Town and Country Planning Act 1990 Appeal under Section 78

APP/W0340/W/20/3265460

Sandleford Park, Newbury

Rebuttal Evidence prepared by Owen Jones BA Hons Dip TP MSc MRTPI

Appendix 4: Vectos drawing VD17562-STR-SK-004 – revised bridge abutment

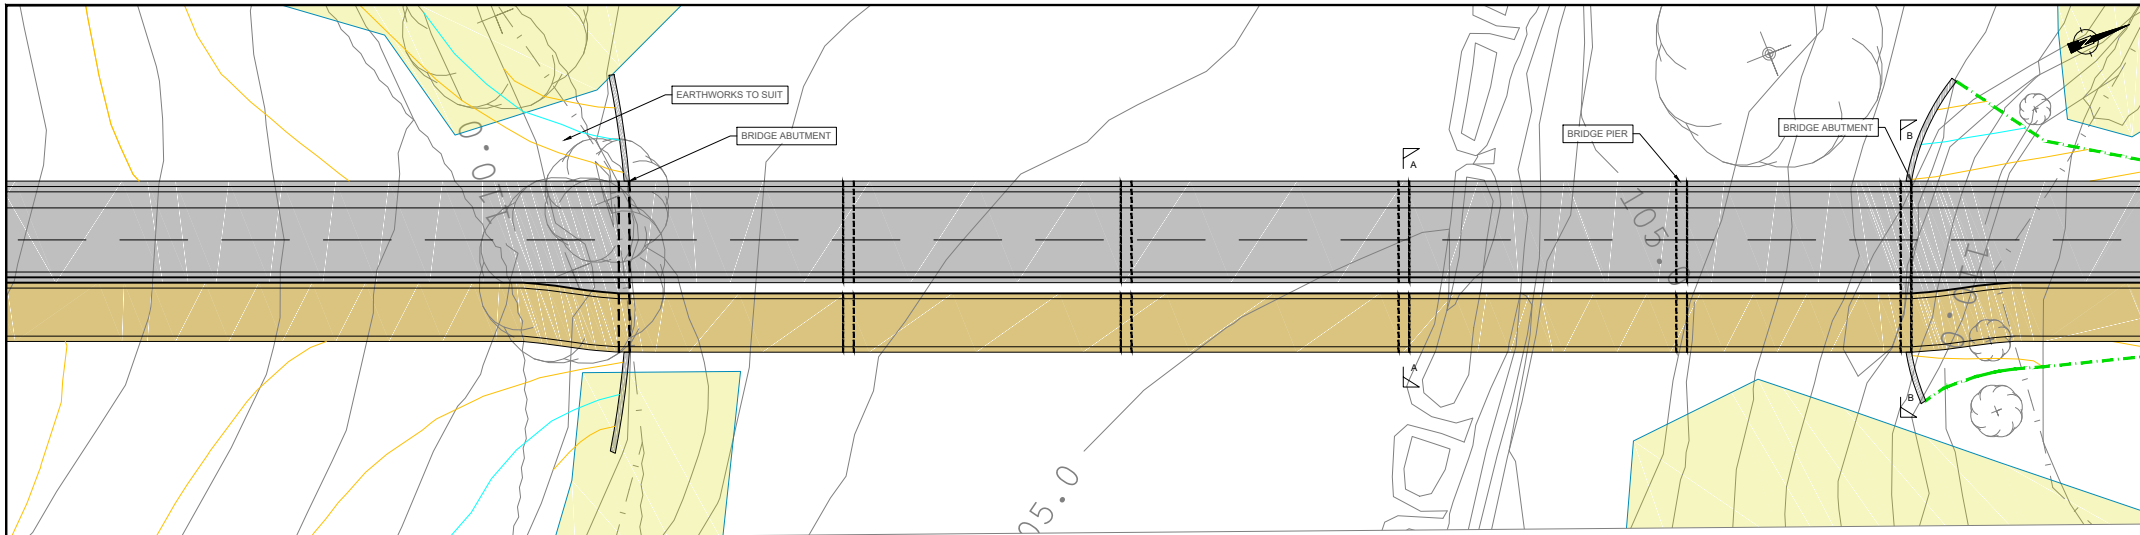
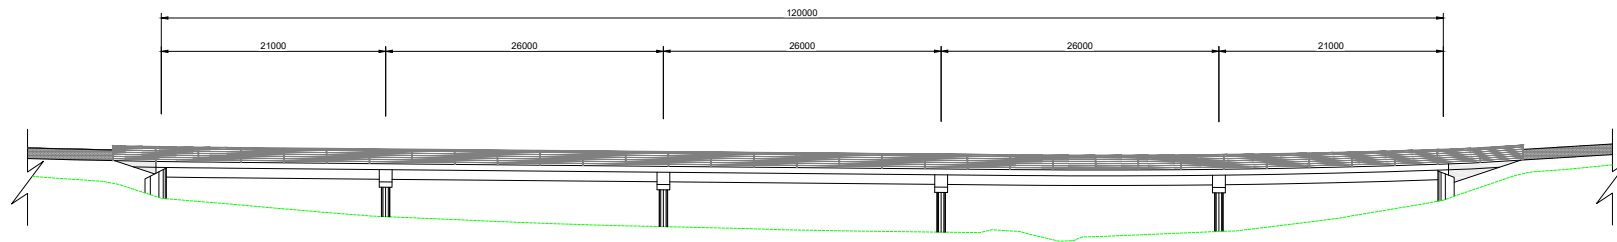
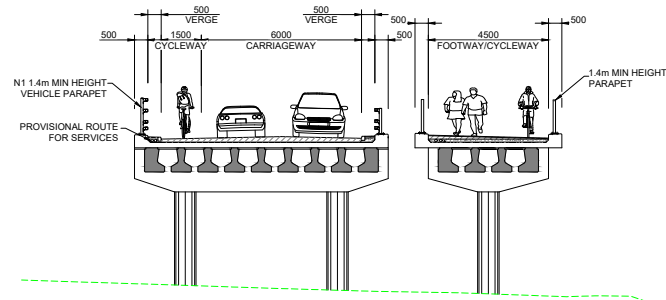
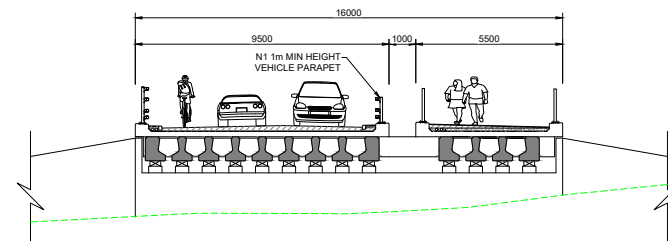
- 2.33 Mr Flatman also indicates that Option 3 goes part way to addressing the criteria set out in the SPD and that a refinement of the bridge abutment would still be necessary. I have included such a drawing at *Appendix 4* to illustrate how this can be achieved. Mr Flatman also refers to this Option negating the need for the emergency access through the Parkland area and that is this a more appropriate and less harmful solution in landscape terms.
